**Community Advisory Board
for
Nevada Test Site Programs**

WELL SITE RECOMMENDATIONS

**Presented To:
Underground Test Area
Technical Working Group
August 23, 2007**

West Greeley Fault

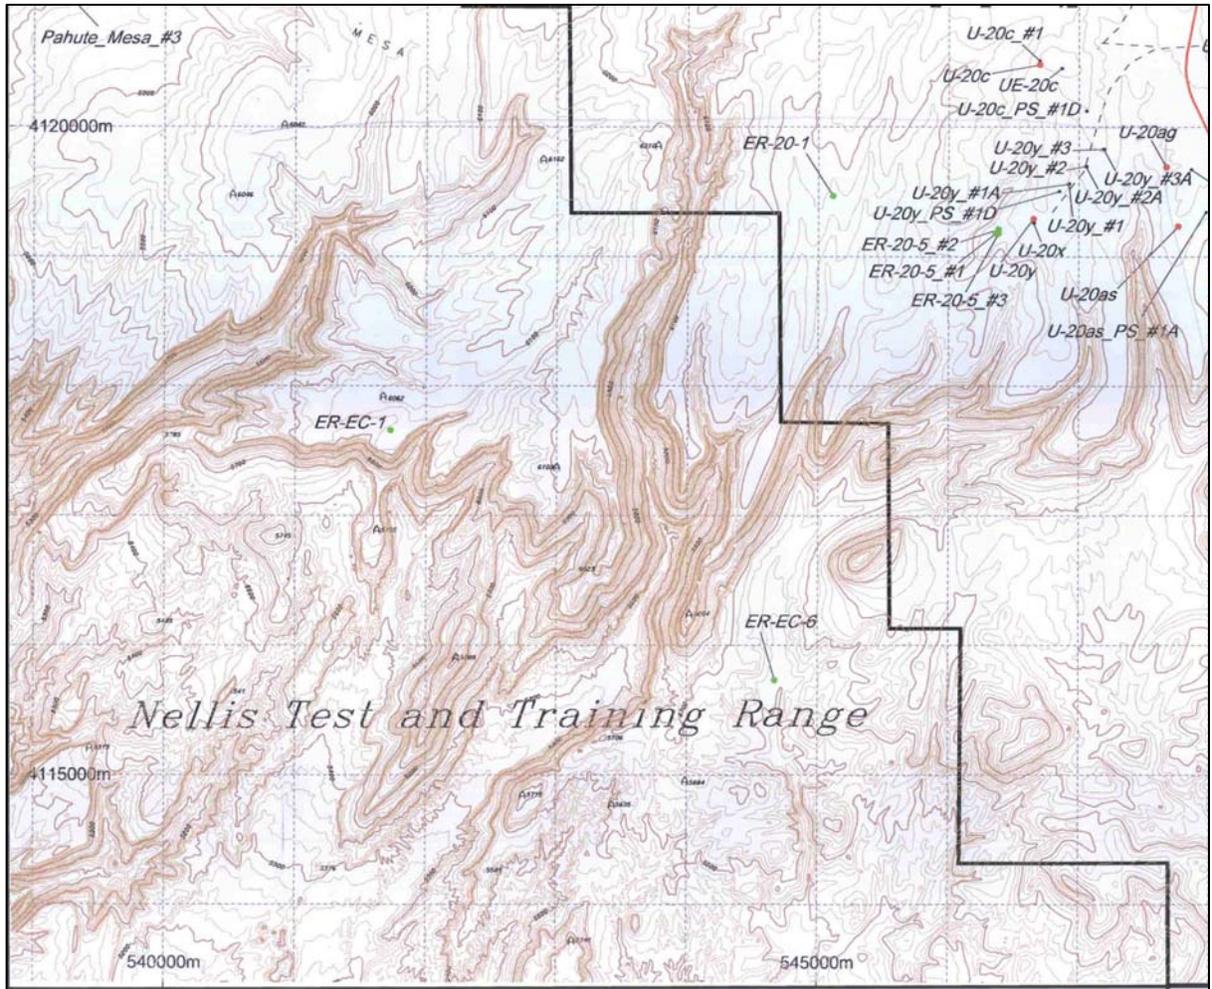
Well Site Recommendations

- Well Site 1:
 - Install a well down-gradient of ER-20-5#1
 - Close enough to intersect contaminants
- Well Site 2:
 - Install a well down-gradient of Well Site 1
 - Approaching the “bench” structure and ahead of the plume
